Item 9.1 Community Consultation- Bike Path Jerrabomberra Circle and Community Consultation-
Shared Path McEwan Avenue

ATTACHMENT 1 JERRABOMBERRA CIRCLE CYCLE PATH REPORT

ATTACHMENT 3MCEWAN AVE PUBLIC CONSULTATION REPORT

ATTACHMENT 2 JERRABOMBERRA CIRCLE CYCLE PATH CONCEPT DESIGNS

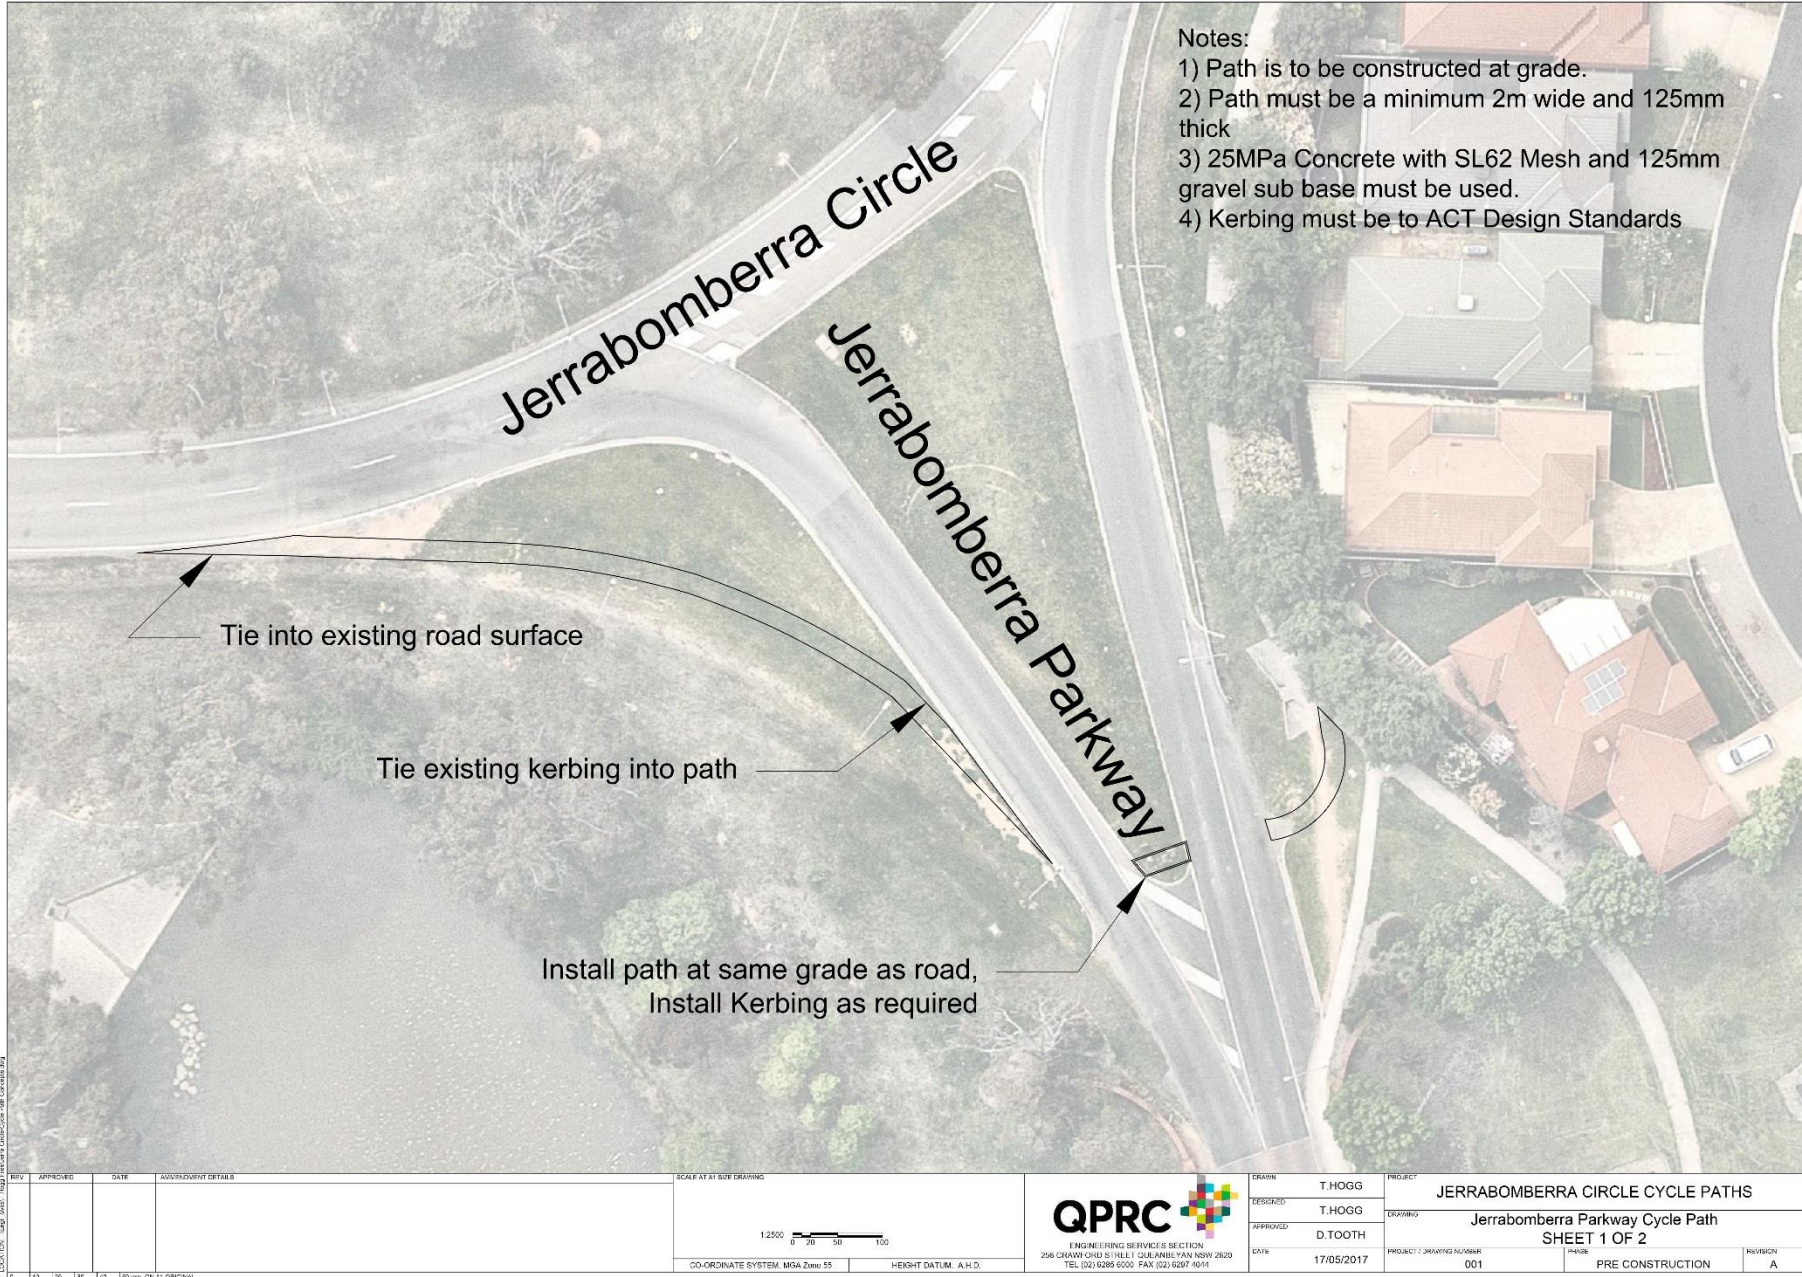
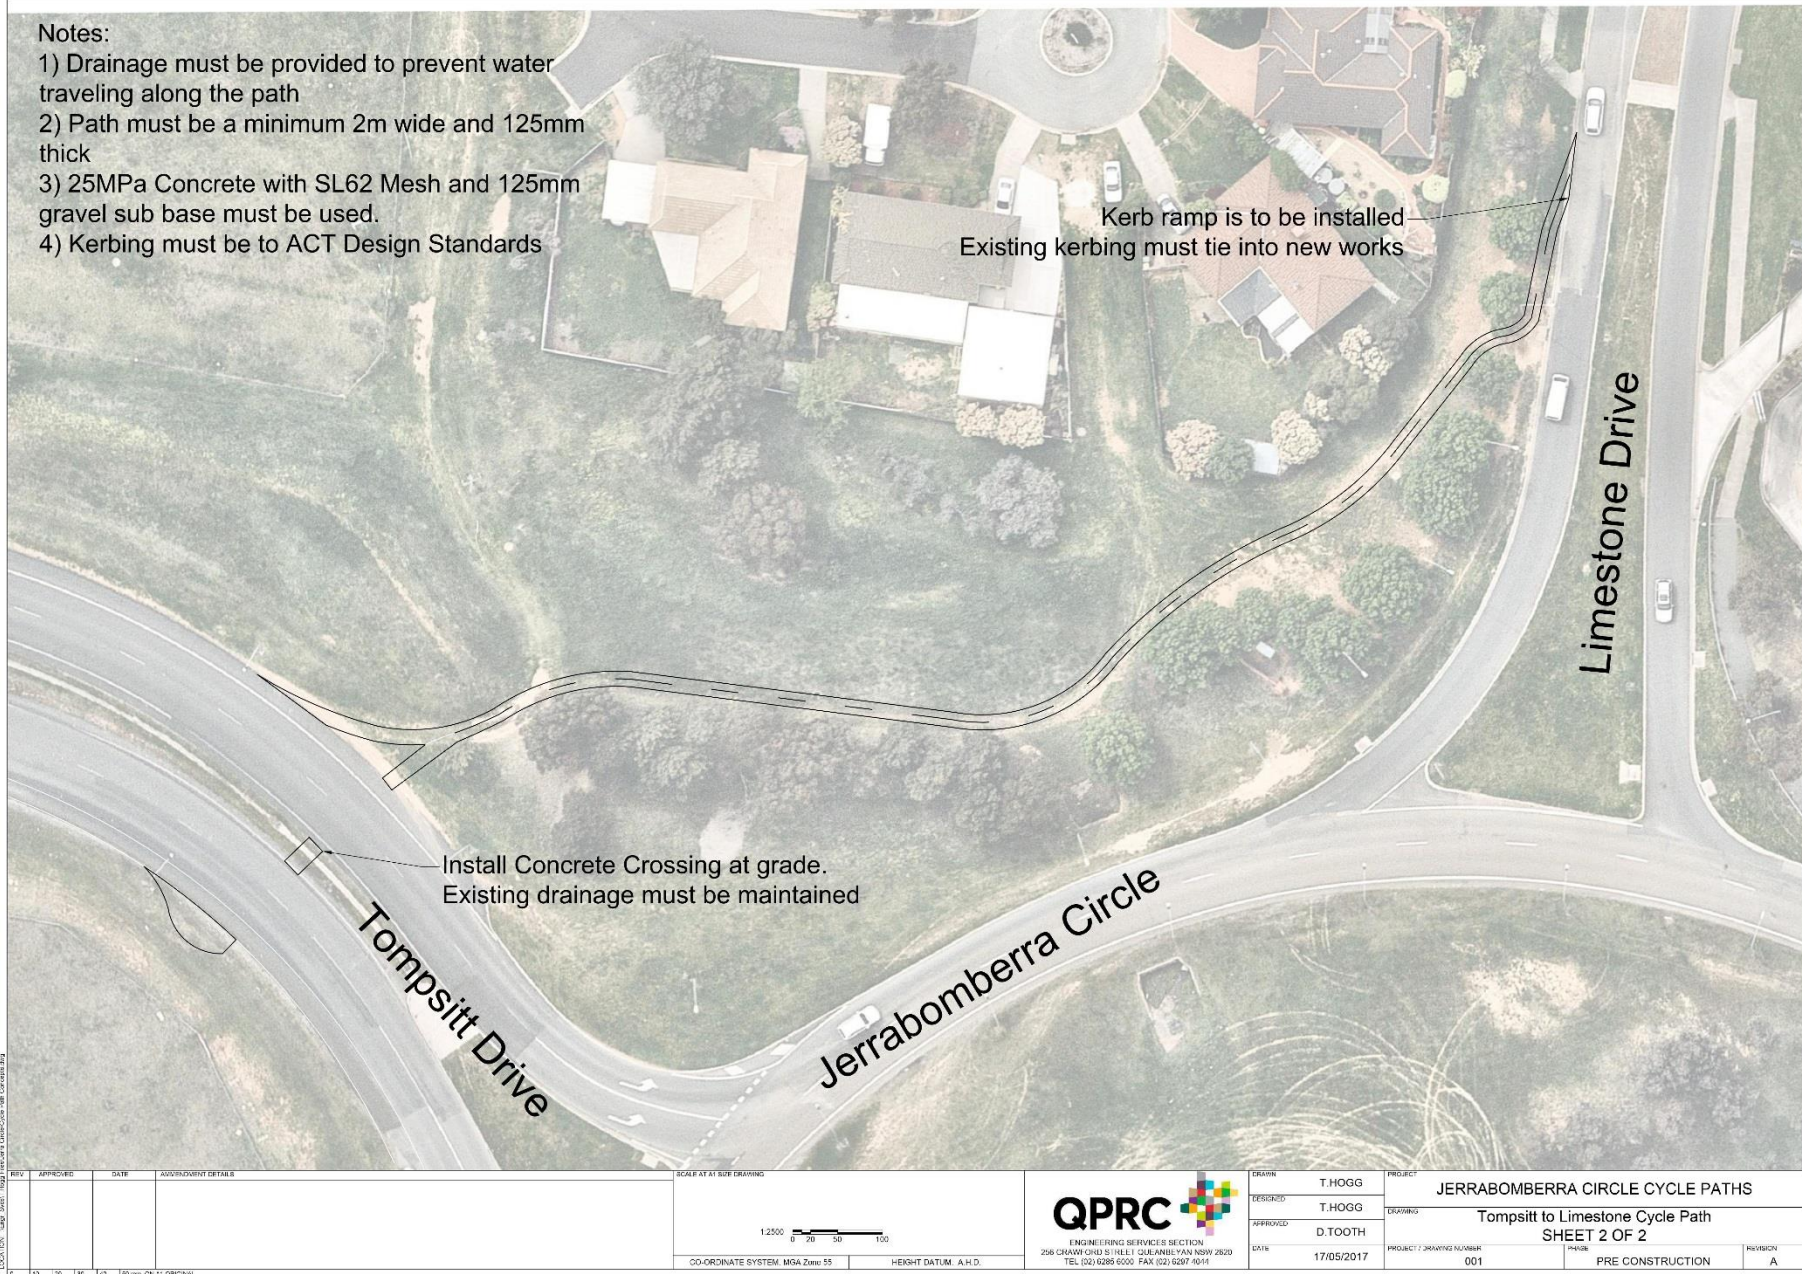
- Privacy issues for residents (1 submission).
- Ensuring infrastructure is user friendly for cyclists travelling at speed (2 submissions).
- Ensuring Infrastructure minimises risks to security and safety (4 submissions).

One submission received was concerned about potential for flooding across the cycle path. This issue has been noted however the risk to cyclists during flooding events is less than the risk to cyclists who either use the road or a cycle path along the side of the road. Between 2011 and 2016 66% of vehicle crashes were crashes that potentially may have collided with a cyclist had the cyclist been on a cycle path next to the road or a cyclist on the road. 1 vehicle crash recorded at Jerrabomberra Circle between Tompsitt Drive and Limestone Drive was a rear end crash.

Community feedback for the concept showed no opposition to installing the cycle paths. All feedback received were from people who supported the concept of installing this infrastructure. Concerns, however, were included in the feedback received that have been incorporated into the updated design of the cycle paths.

The final cycle path designs were updated to ensure that the feedback was integrated into the designs. The final cycle path designs will allow cyclists to cross Tomsitt drive and will enable cyclists to negotiate less tight turns than the previous path options. The route has been adjusted to provide resident privacy whilst also ensuring that cyclists are separated from vehicles.

The concept designs for the cycle paths have been updated to accommodate for public consultation feedback. All feedback provided has been noted.
